URGENT FIELD SAFETY NOTICE

GEHC Ref# 32047-2

RE: Infant Warmer System (IWS) Hot "Heater Head" Screw could Fall onto the bed

This is a correction to a previous notification that you could have received and adds two additional model numbers to the Affected Product Details section; see bold underlined model numbers below.

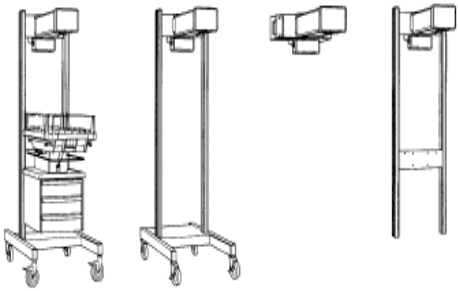
Hot screws from the "Heater Head" of the IWS could fall onto the bed if the "Heater Head" assembly has been improperly serviced. This situation can be clinically hazardous because thermal injury to a patient could result. Two injuries have been reported as a result of this issue.

As a result, if "Heater Head" service has been performed in the past, check to ensure that the screws are tightened as soon as the unit becomes available.

If the "Heater Head" assembly has not been serviced, check to ensure that the screws are tightened as part of your next regularly scheduled annual Preventive Maintenance check.

The attached Service Manual Addendum provides instructions for checking and tightening the screws. During each annual Preventive Maintenance check, continue to ensure that the screws are tight.
